**DEVIATION REQUEST
 AND DECISION FORM**

Project Name : Eagleview Subdivision
 Schedule No.(s) : 5226000001), 5226000001)
 Legal Description : N2NW4 EX WLY 620.0 FT SEC 26-12-65,S2NW4 EX WLY 620.0 FT SEC 26-12-65

DEVIATION No. 2 - A deviation from the standards of or in Sections **2.3.8.A** of the Engineering Criteria Manual (ECM) is requested. Please refer to **Deviation Exhibit 1**. Two other deviation exhibits are also included. These are introduced and referenced below.

DEVIATION No. 3 - A deviation from the standards of or in Sections **2.3.2 and 2.2.4.A.5** of the Engineering Criteria Manual (ECM) is requested. Please refer to **deviation exhibit 1**. Also attached is **deviation exhibit 2**, which is referenced in the "explanation of the proposed alternative" section below.

FIGURE D103.1 MINIMUM DEAD-END FIRE APPARATUS ACCESS ROAD TURNAROUND.

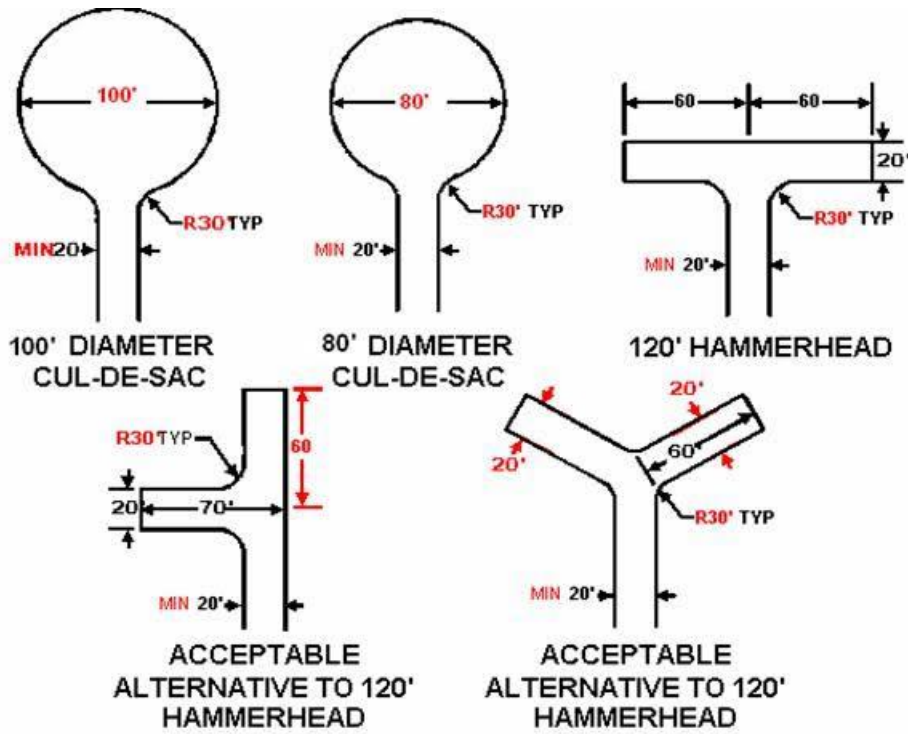
Lots 35, 36 and 37. Ideally the cul de sac extends to the corner of lots 35 and 36 with an individual lot flag stem to lot 37 as an option. See turn around and fire access road requirements below.

Lots 31 and 32. This access is the one we have the most issue with. See fire access road requirements below. Each lot should have direct access individually to the main road. Flag stem lots are acceptable. Access serving more than one address are not driveways, they are Fire Apparatus Access Roads and are required to meet the Fire Code and County requirements for fire access roads.

Figure D103.1 Dead-End Fire Apparatus Access Road Turnaround. Delete Figure D103.1 and replace with the following:

Exhibit 1

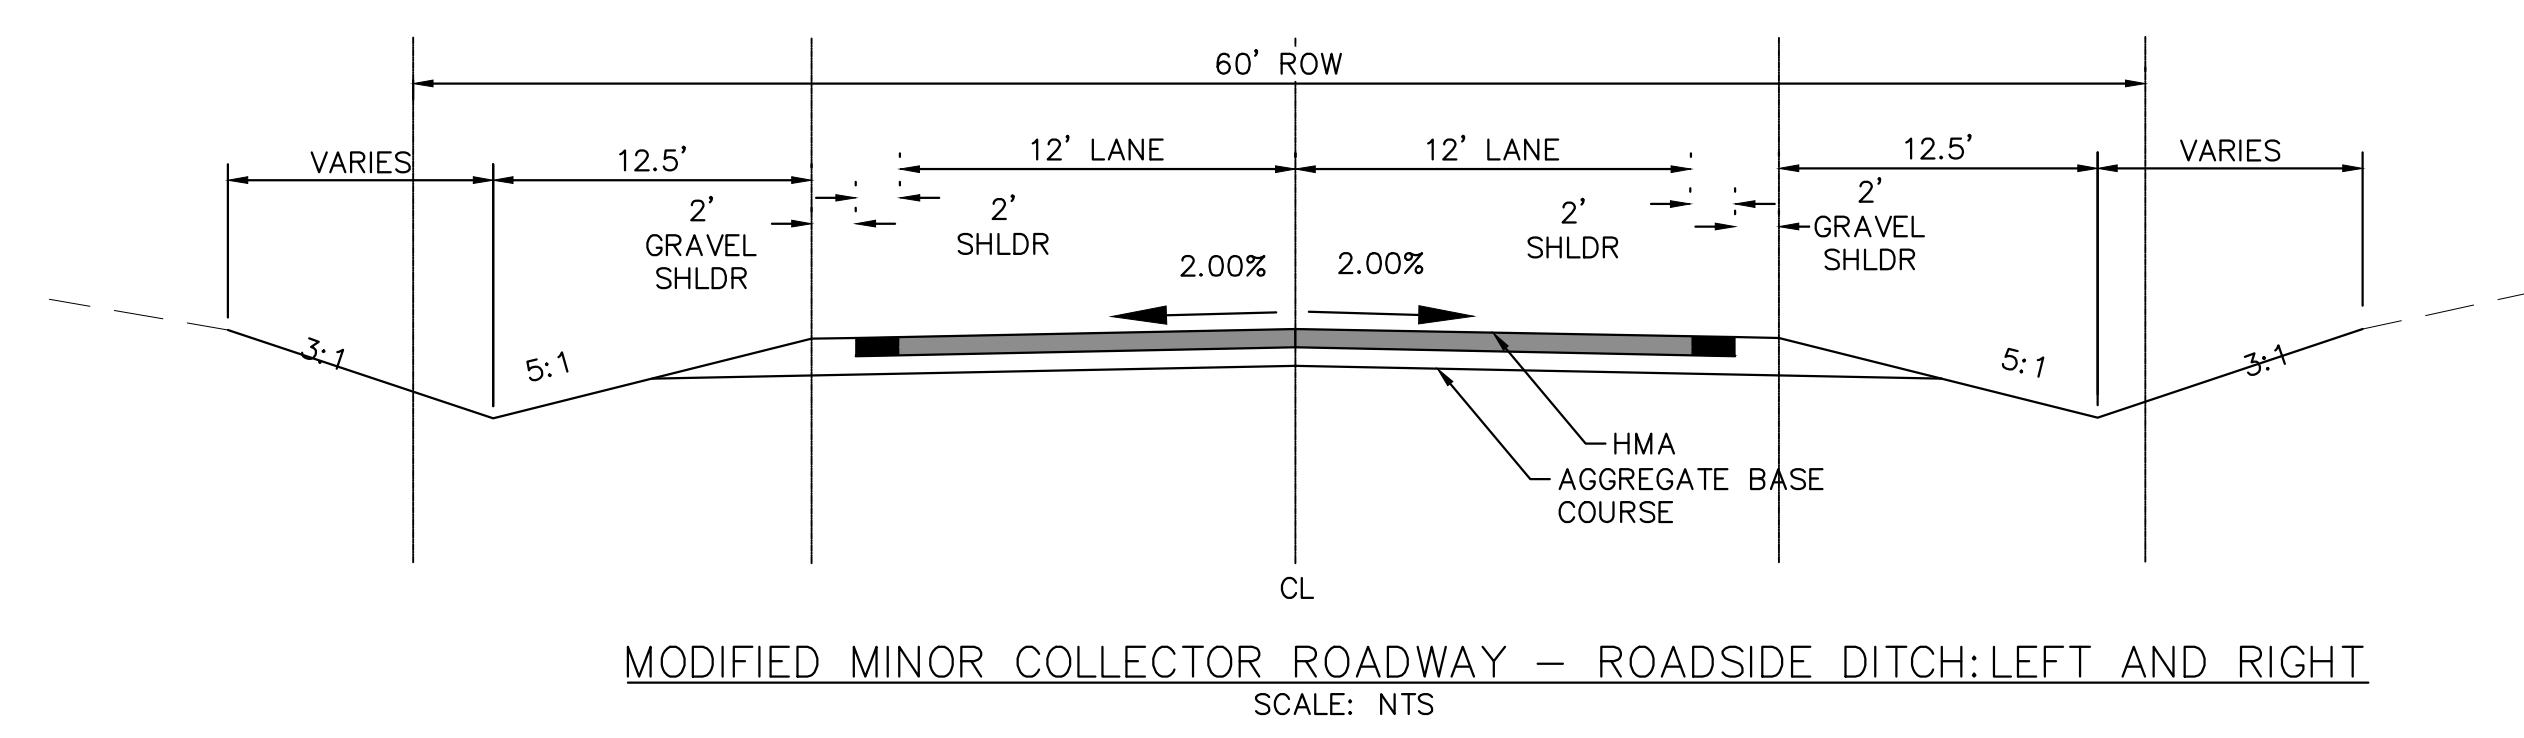
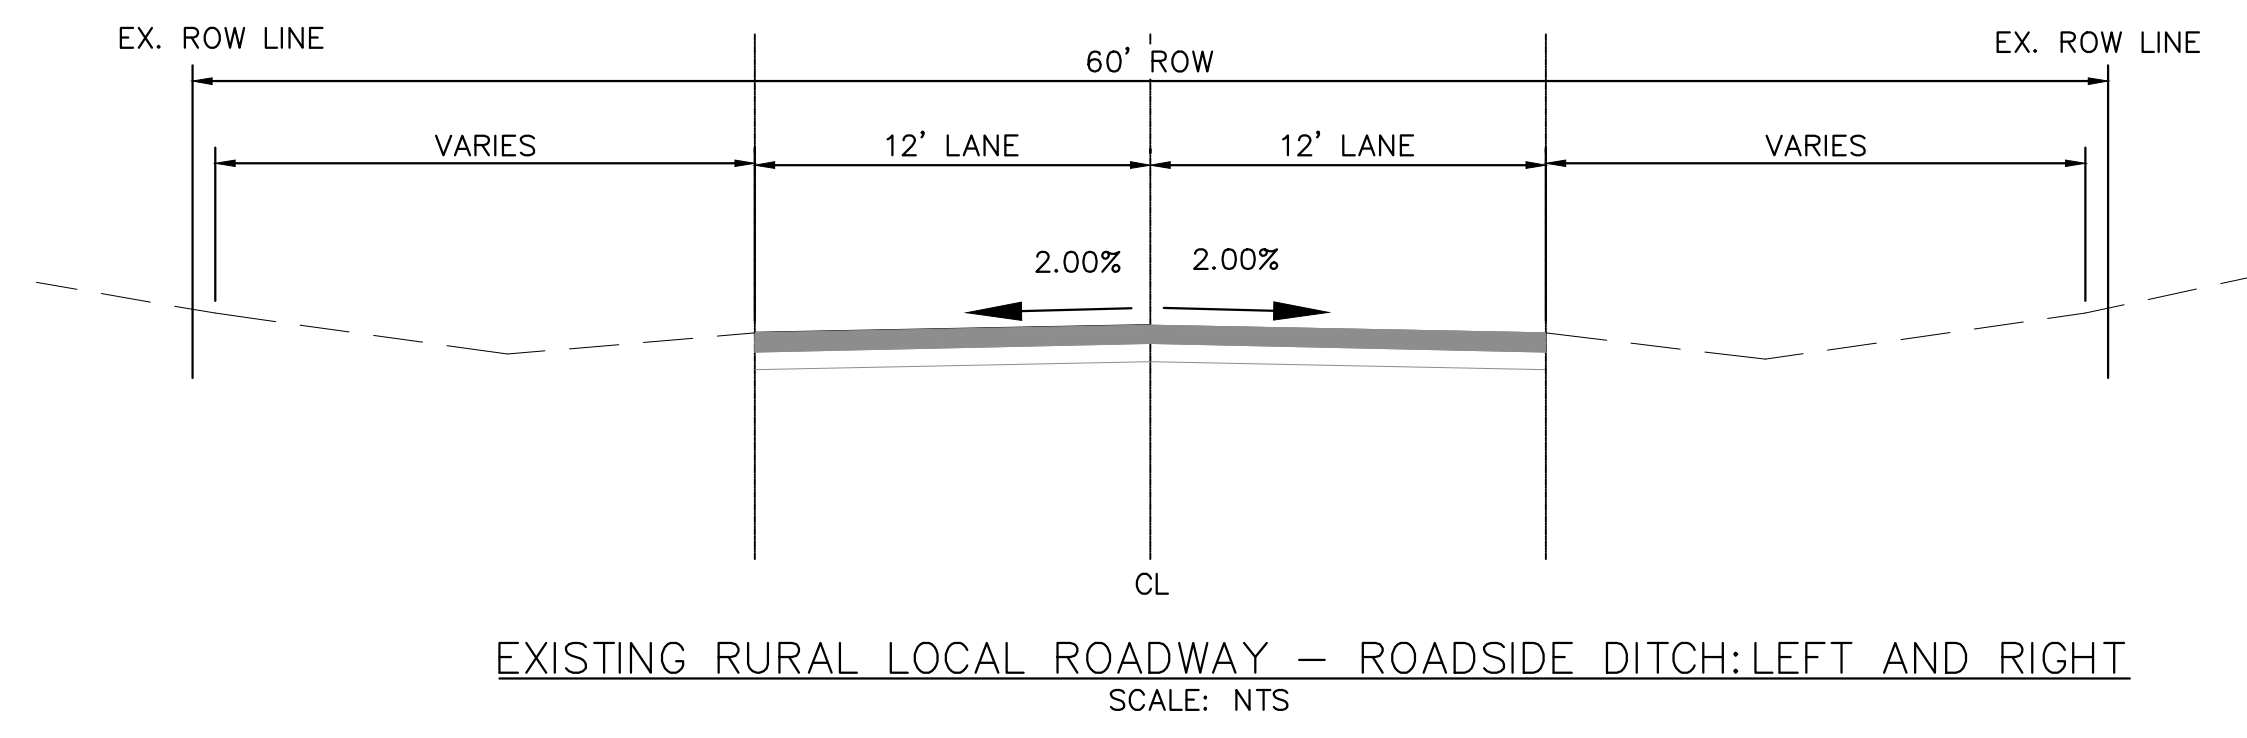
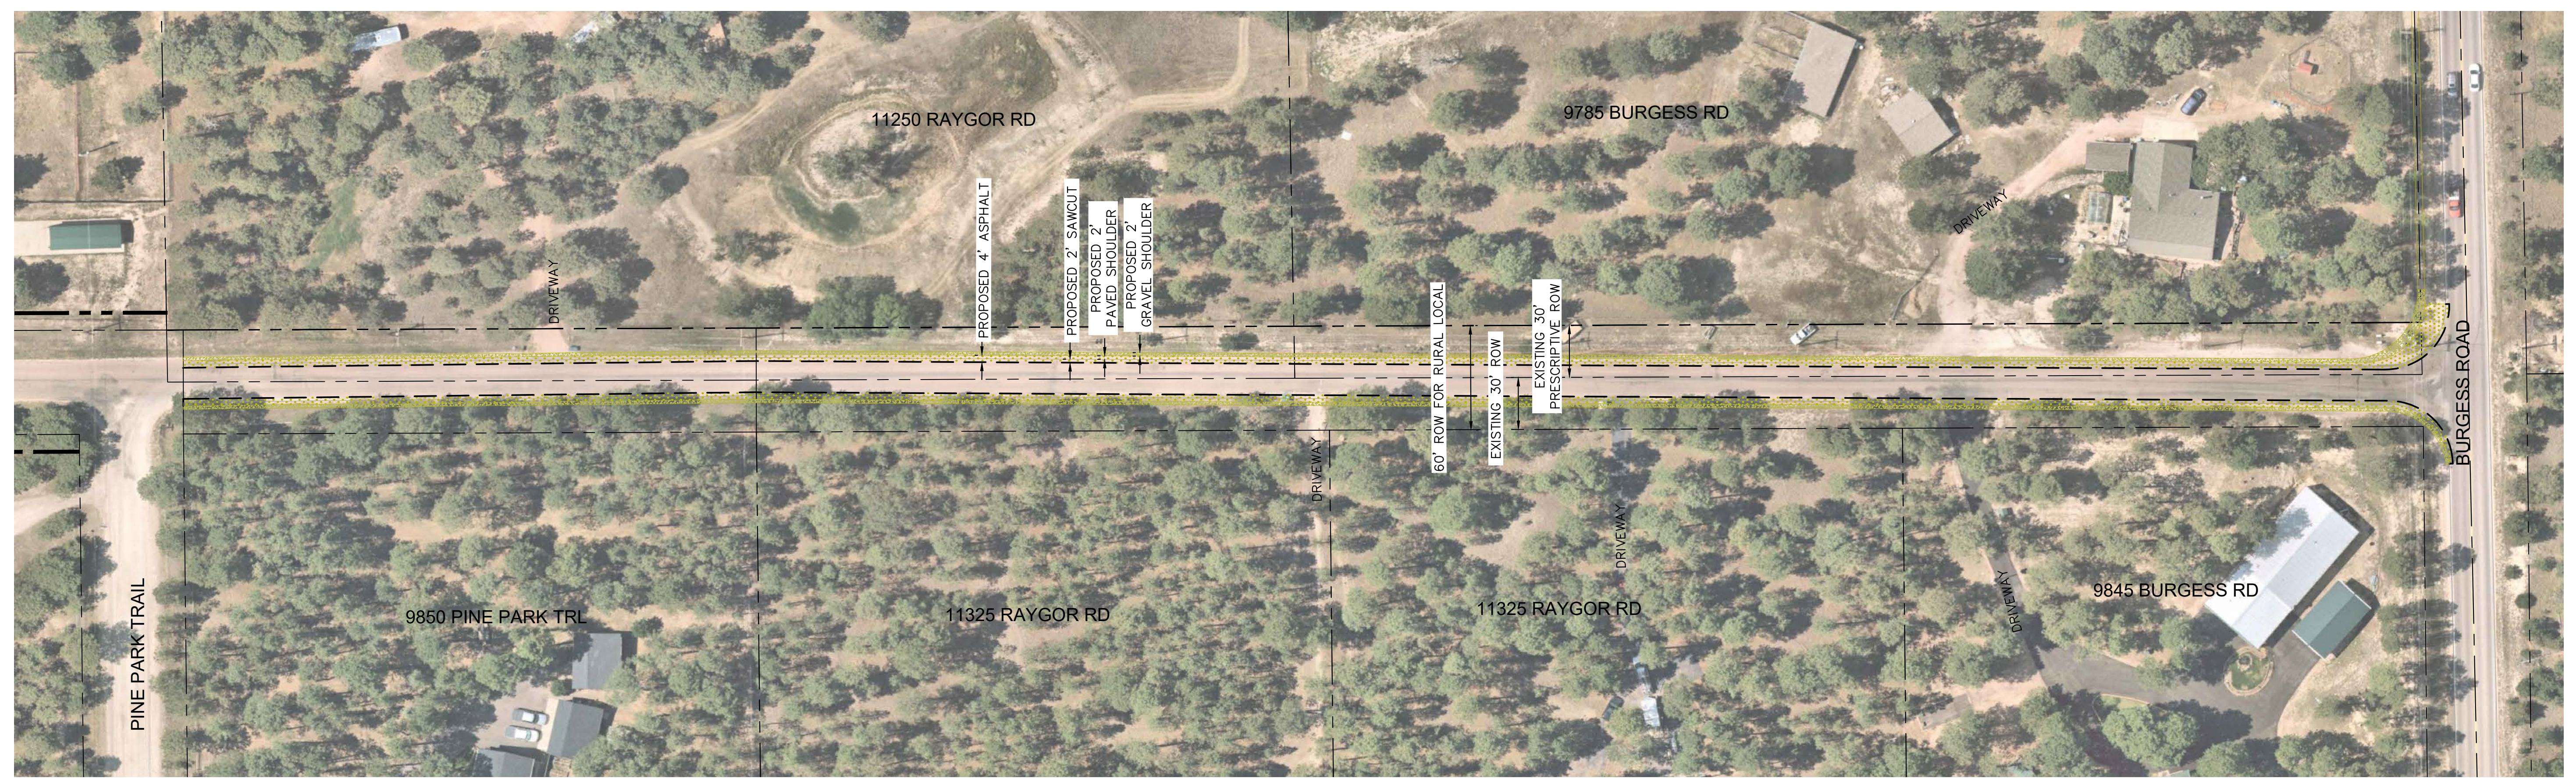
The ADT at the **north end** of Raygor Road is likely within the range of a Rural Minor Collector, currently, even prior to the additional trips estimated for this subdivision. The current Raygor Road ROW and cross section do not meet the ECM standard for a rural minor collector, therefore a deviation is required.

The proposed alternative is to provide an 18-percent fair share of the cost to upgrade Raygor Road to a 28-foot wide paved standard including two-foot paved outside shoulders plus two-foot gravel shoulders. Instead of paying an escrow for the 18 percent of the cost of this improvement, the applicant proposes to complete the improvement on the north end of Raygor between Pine Park Trail and Burgess. **Please refer to deviation exhibit 2**. This is the segment with the highest volume and this construction of a portion in lieu of escrow would put the improved road in-place for the highest volume portion rather than having the funds sit in escrow. The right of way is generally 60-feet. By comparison, the ECM standard Rural Minor Collector cross section has 80-feet of right of way with a 32-foot paved width and 2-foot gravel shoulders (plus roadside ditch sections). The ECM standard pavement section is 3 inches of asphalt over 6 inches of base.

This request has been determined to have met the criteria for approval. A deviation from Section 2.3.2, 2.2.4 A5 of the ECM is hereby granted based on the justification provided.

Asphalt widening to mill and overlay a minimum of 12 inches of existing asphalt from the sawcut line. Street construction plans submitted with the final plat application to finalize the extent of mill and overlay.
